# P 23 086 SUPERSEDED BY P 23 145

## P 23 086 WVA (23711-23712) → P 23 145 (WVA 23711-23713)

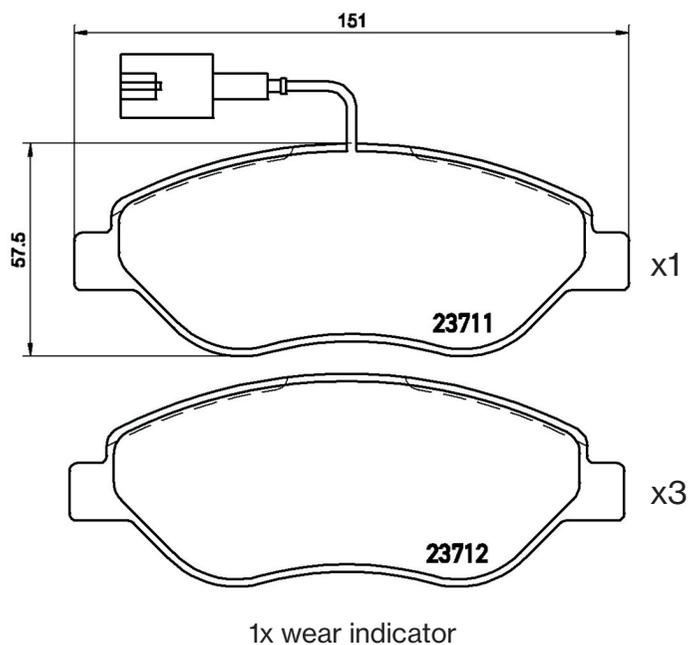
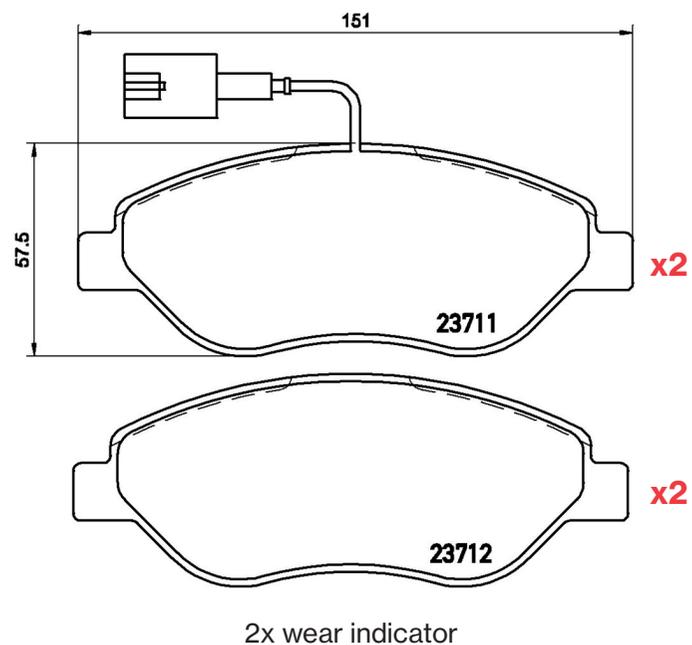
For the reference P 23 086, Fiat changed the corresponding OES reference from one wear indicator to two wear indicators per set. Wear indicators that are not used have to be simply cut off during assembly. Brembo will perform the same change, according to the OES programme. P 23 086 will be replaced by P 23 145

Existing stock of P 23 086 can be sold out. Please consider that P 23 086 can be used only for vehicles equipped with one wear indicator.
